RE: Lycee Francais Renovation
1601 Leonidas Street
New Orleans, LA 70118
Proposal # 048

ARCHITECT'S SUPPLEMENTAL INSTRUCTION NO: 020**DATE OF ISSUANCE: 7/20/21**

Project: LYCEE FRANCAIS DE LA NOUVELLE-ORLEANS (LFNO)
1619 LEONIDAS STREET
NEW ORLEANS, LA 70118

Provide fire and smoke dampers as shown on the attached sheets.

1 THIRD FLOOR - DUCTWORK - PLAN
M2.3 1/8" = 1'-0"

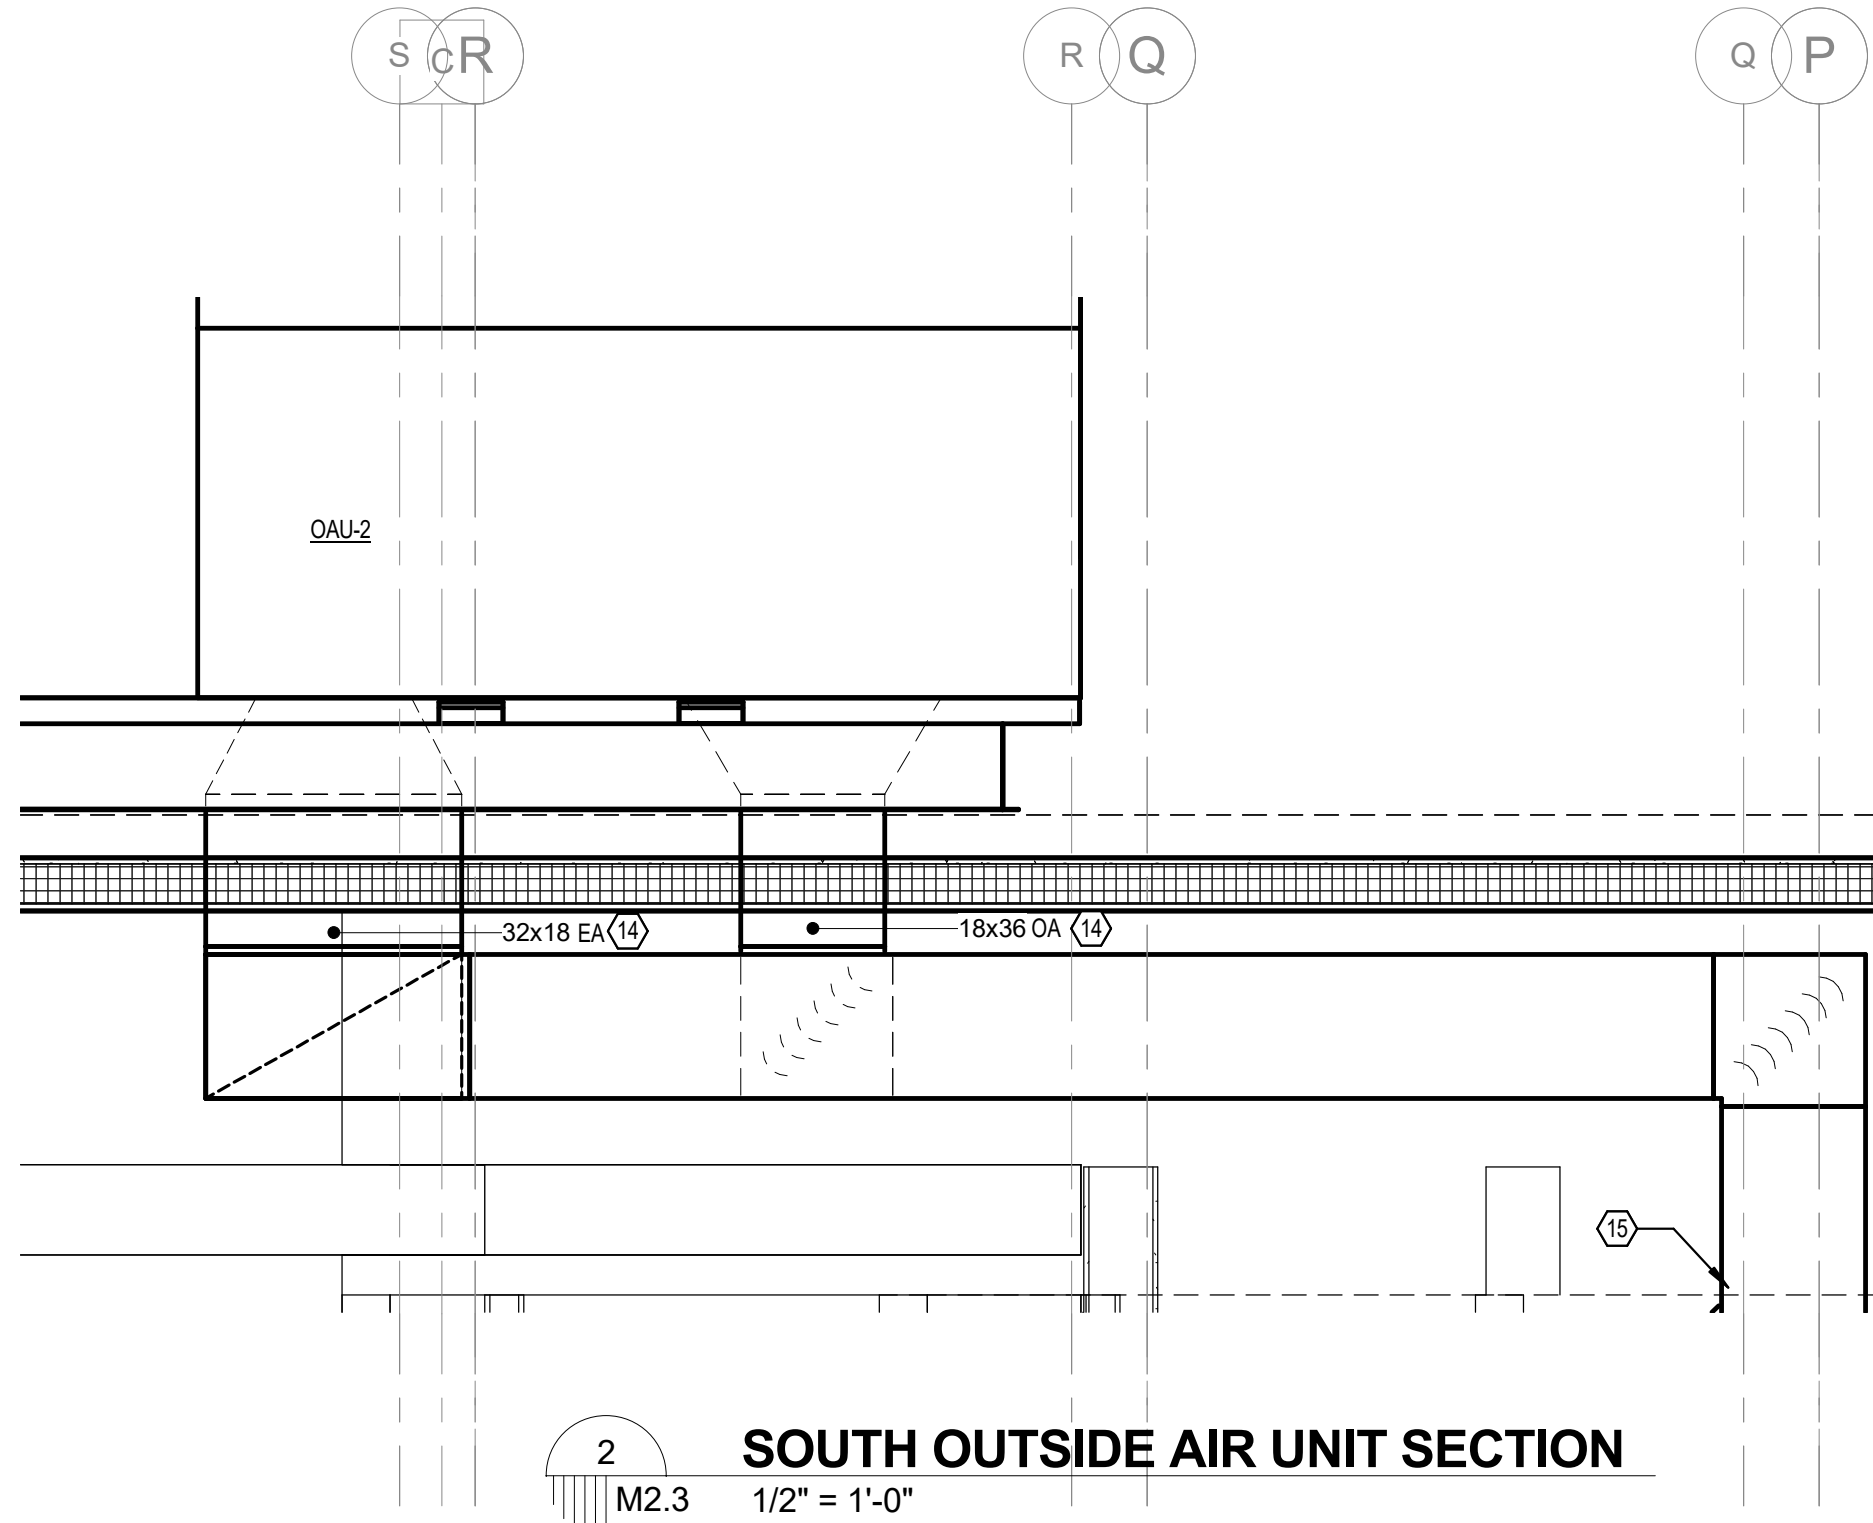
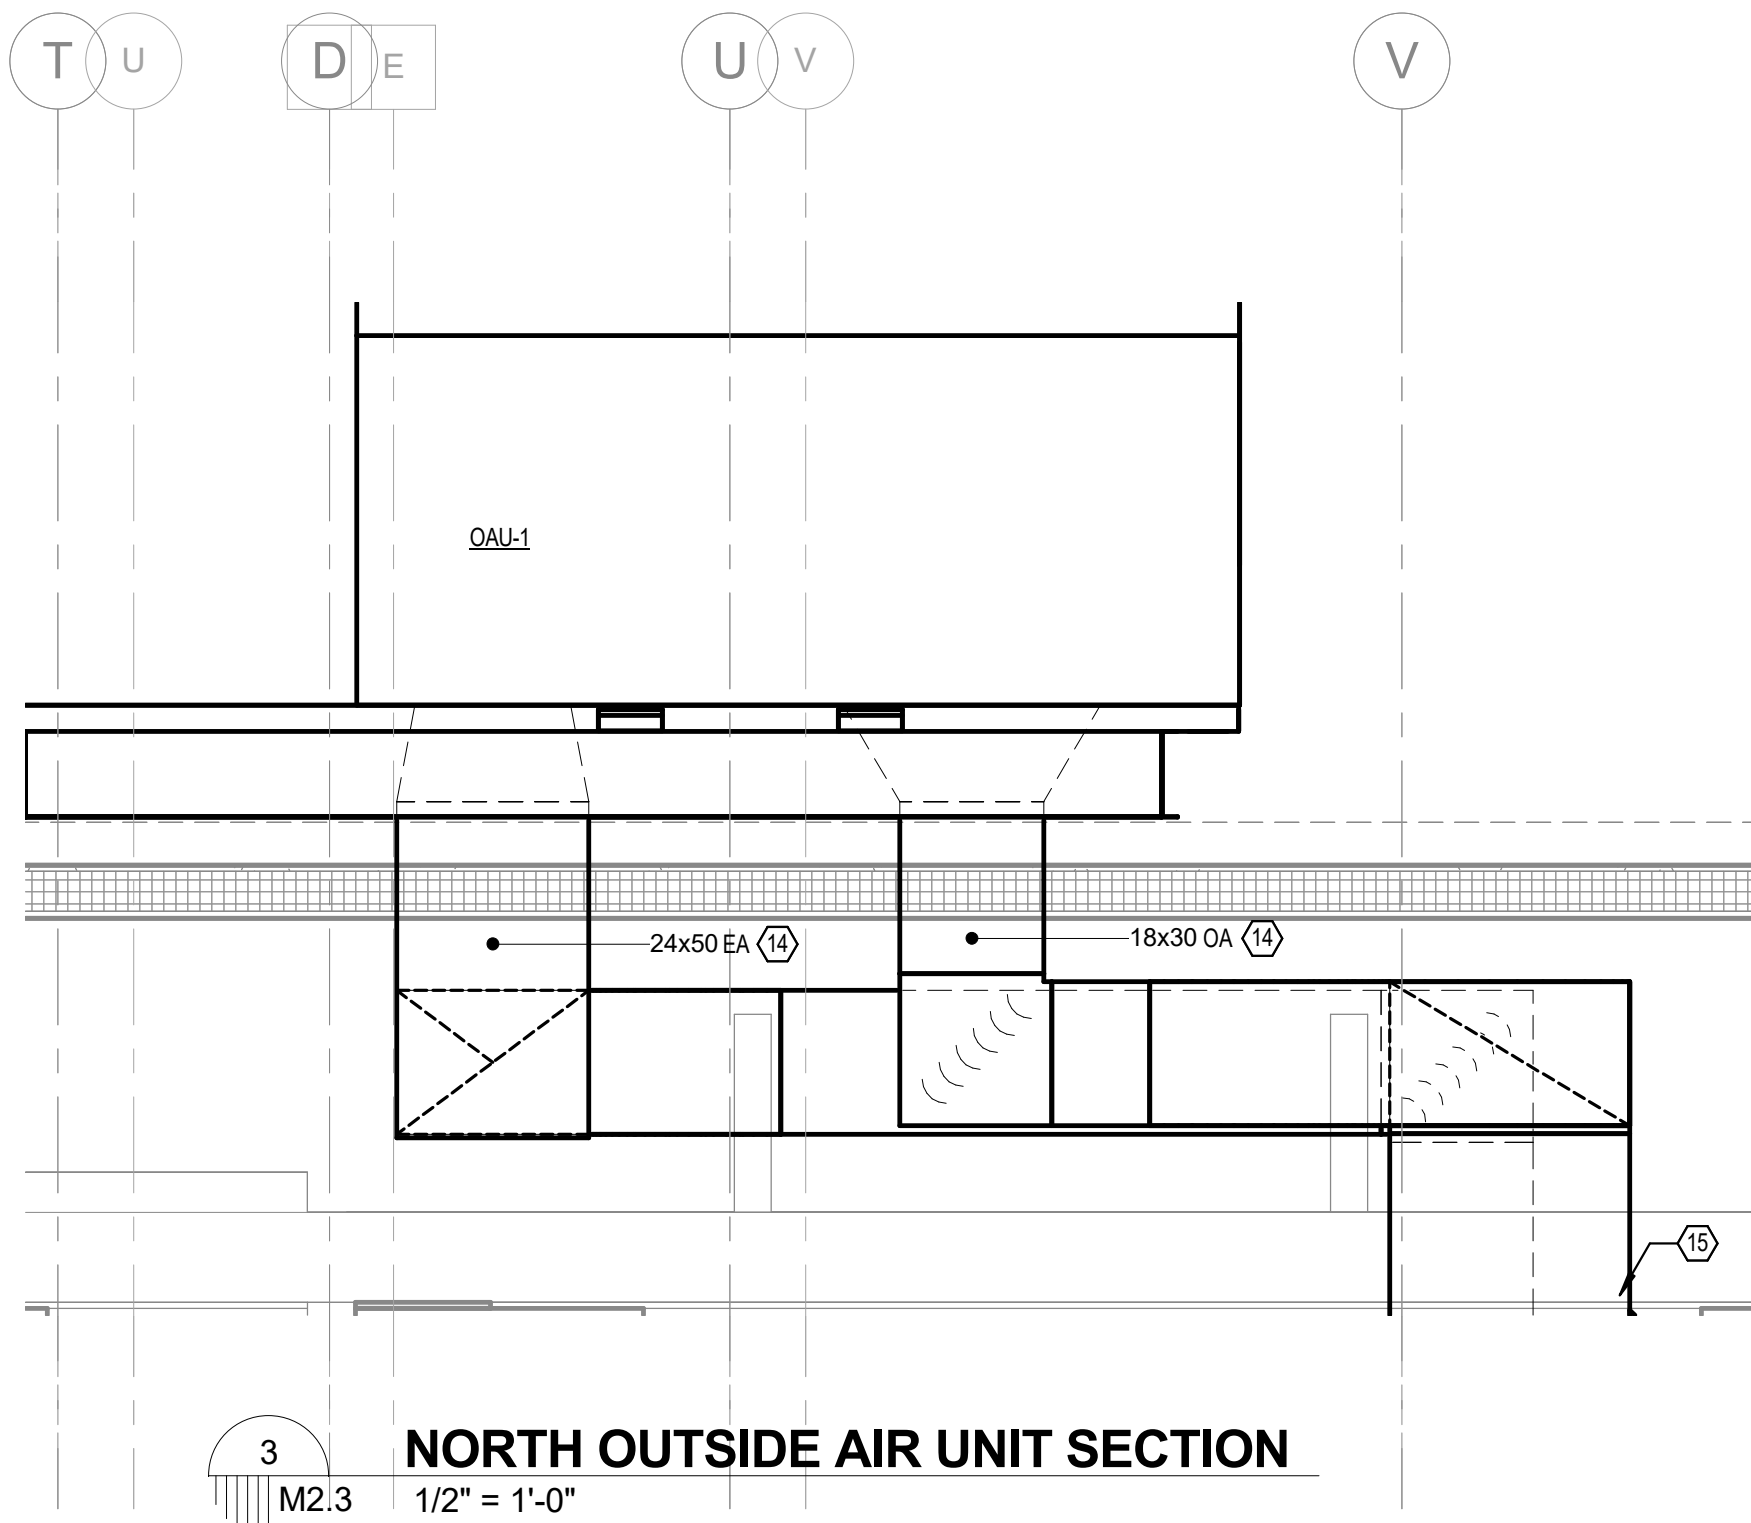
- PROVIDE FIRE SMOKE DAMPERS AT INDICATED LOCATIONS. COORDINATE POWER AND FIRE ALARM WITH DIVISION 26.
 - ROUTE CONDENSATE FOR ADJACENT VRF SYSTEMS TO MOP SINK THIS LOCATION. SLOPE PIPING TOWARDS DRAIN.

- REFER TO 24x50 EA PLAN FOR DUCT CONTINUATION.
 - INSTALL FIRE DAMPER AT FIRE RATED WALL PENETRATION.

1 SECOND FLOOR PLAN - MECHANICAL POWER
E3.2 1/8" = 1'-0"

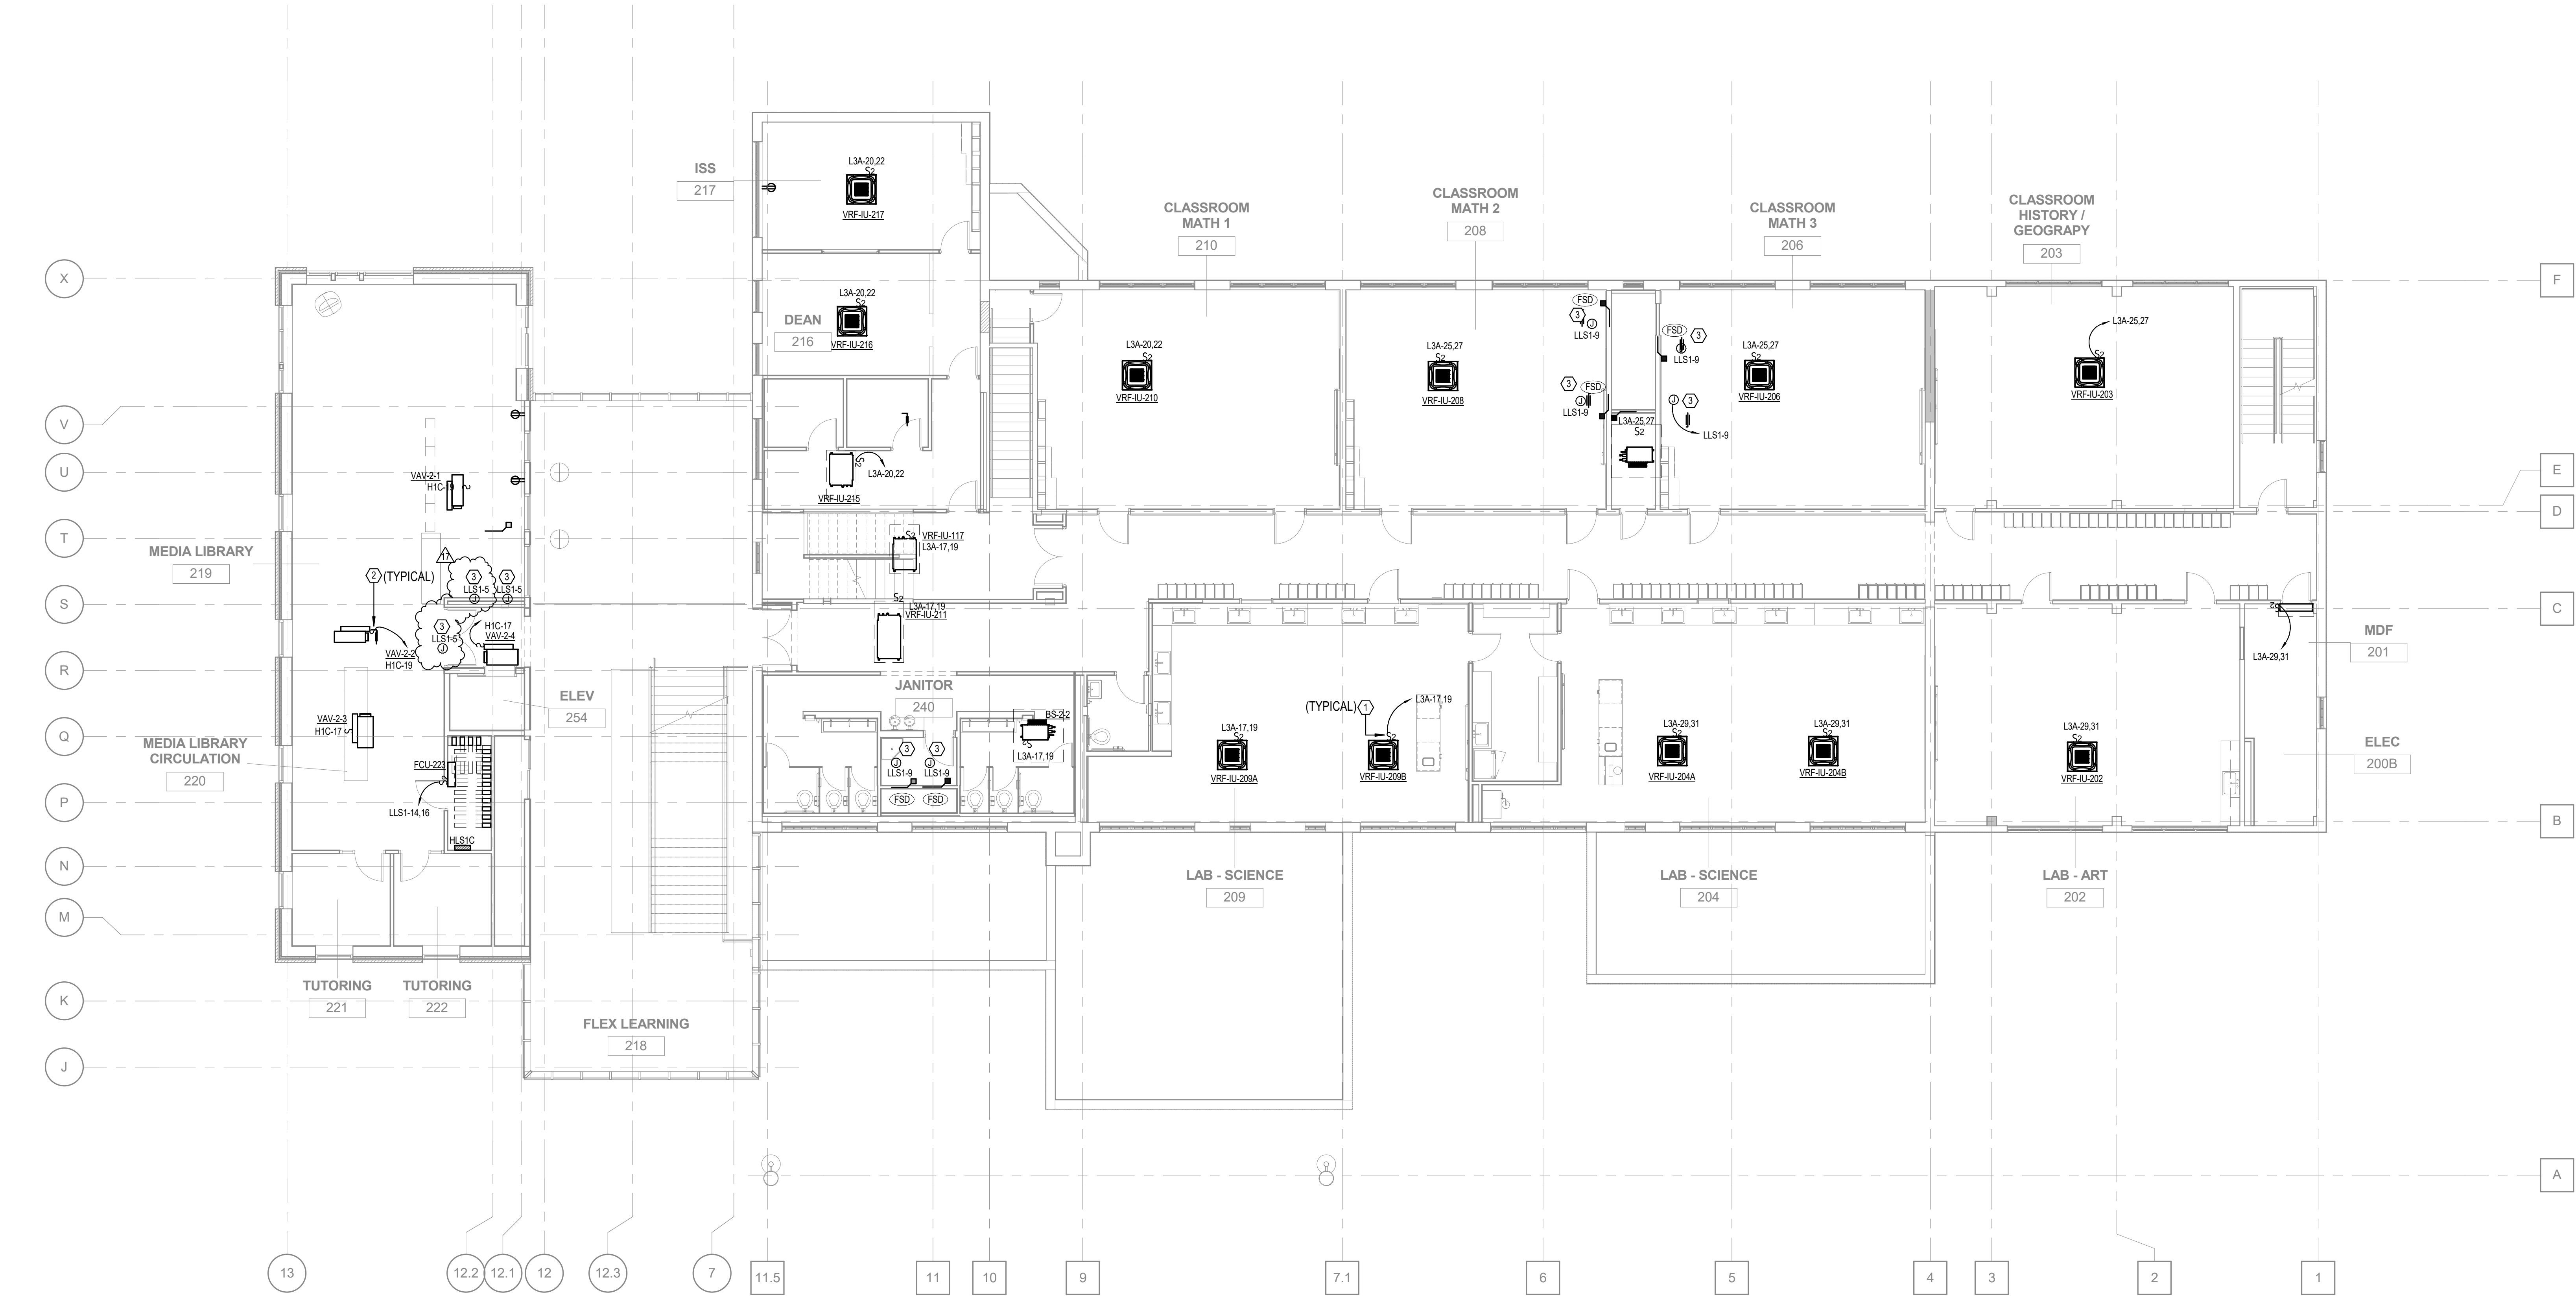
REVISIONS		07/20/2021	ASI #020
17			
3	10/05/2020	PR #001	
11	01/29/2021	ASI #010
